CITY OF ALBUQUERQUE

RE: **Lot 22 Block 8 Volcano Cliffs Unit 22 SAD 228**
6304 Alderete Ct. NW
Grading and Drainage Plan
Engineers Stamp Date 4/17/2021 (D10D003E22)
Pad Certification Date 6/3/2022

DRAINAGE AND TRANSPORTATION INFORMATION SHEET (REV 6/2018)

ENGINEER'S SEAL DAVID SOULE P.E. #14522	LOT 22 BLK 8 U 22 VC 6304 ALDERETE CT.	DRAWN BY DEM
	GRADING AND DRAINAGE PLAN	DATE 3-30-22
 P.O. BOX 53924 ALBUQUERQUE, NM 87199 (505) 321-9099		6304 ALDERETE CT.DWG
		SHEET # C1
		JOB #

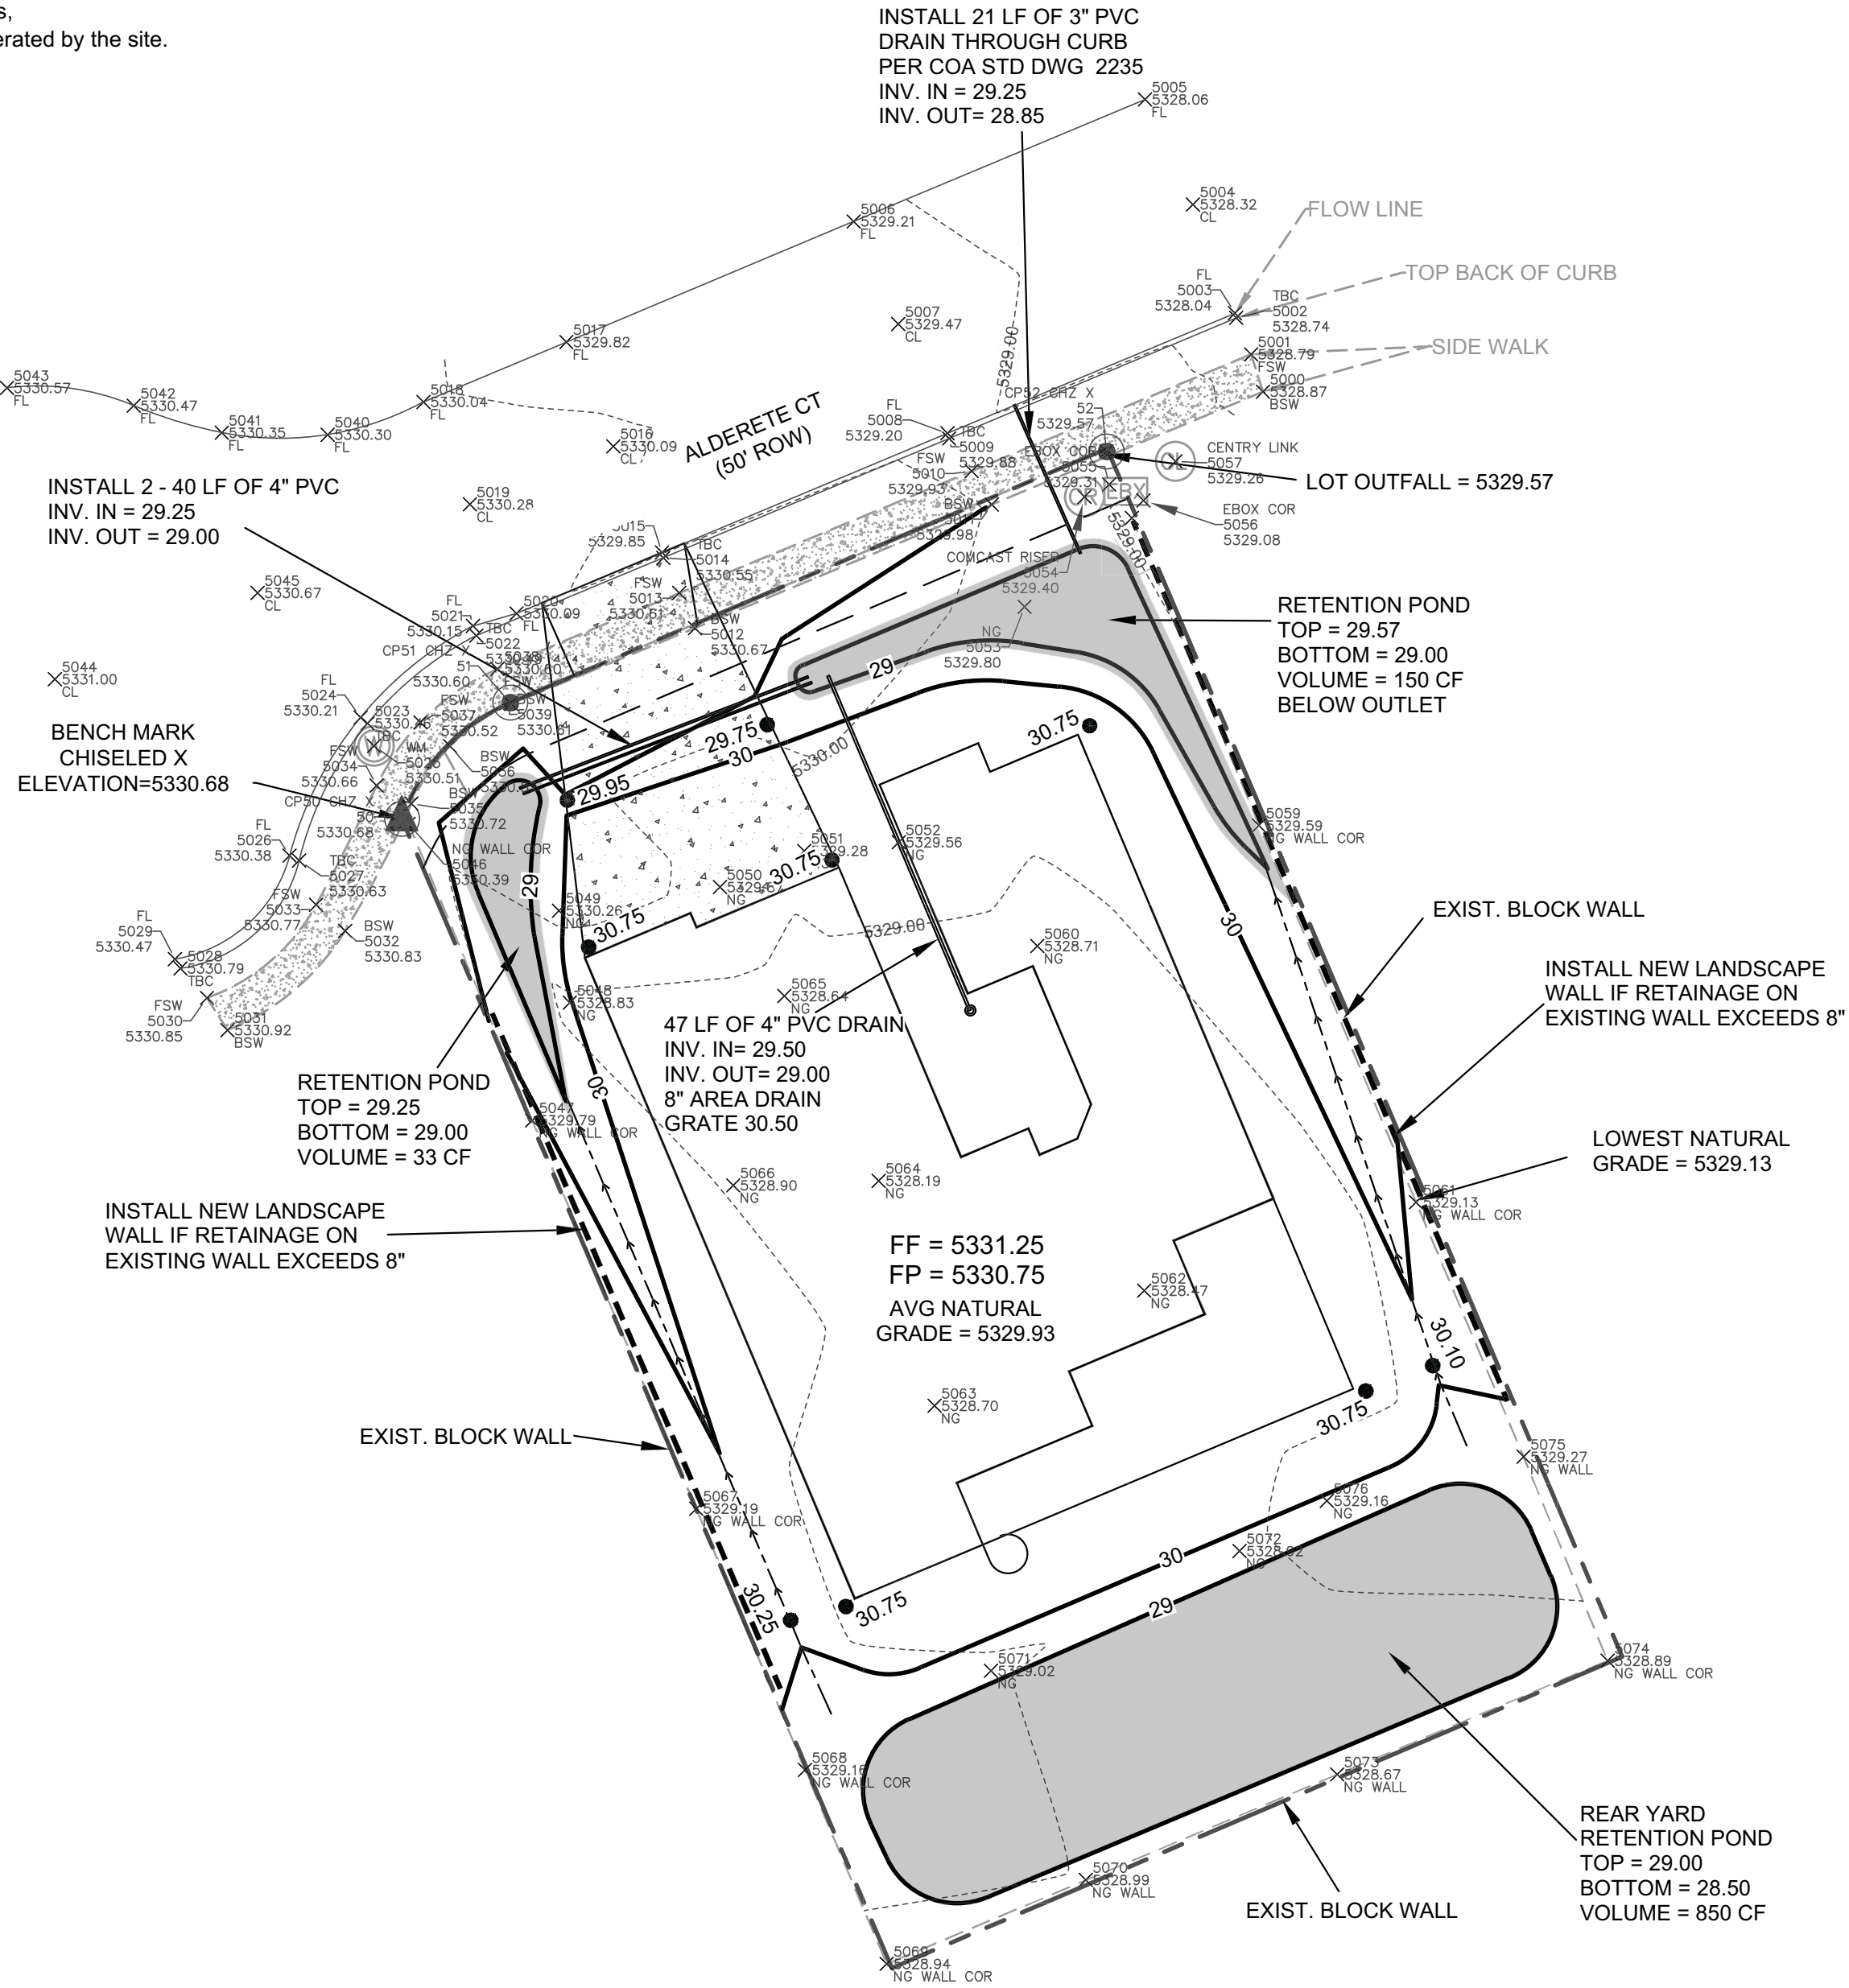
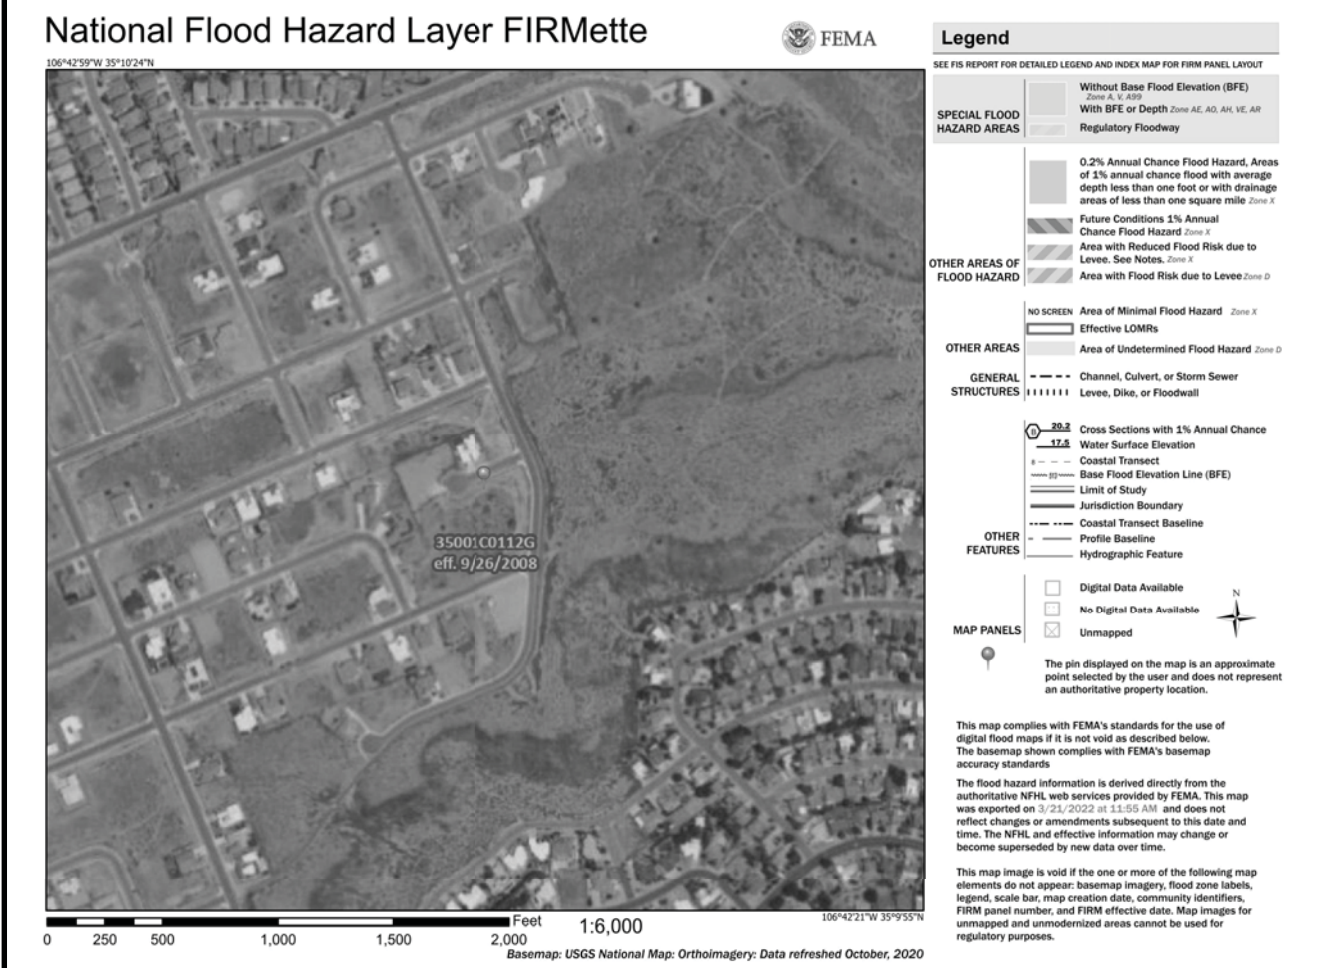
Reiterate to the Owner/Contractor that a separate permit for a garden/retaining wall must be obtained, with the approved G&D plan and Pad Certification. Also, let the owner/contractor know that if a pool is to be added in the future the G&D plan will need to be modified showing the location of the pool and the land treatment differences. Also advise the owner & Contractor that dirt is not allowed in the public right of way to climb the curb. Crusher fines or lumber is allowed. If dirt is used this will delay going forward with the construction of the home.

Based upon the information provided in your submittal received 6/6/2022, this plan is approved for Building Permit.
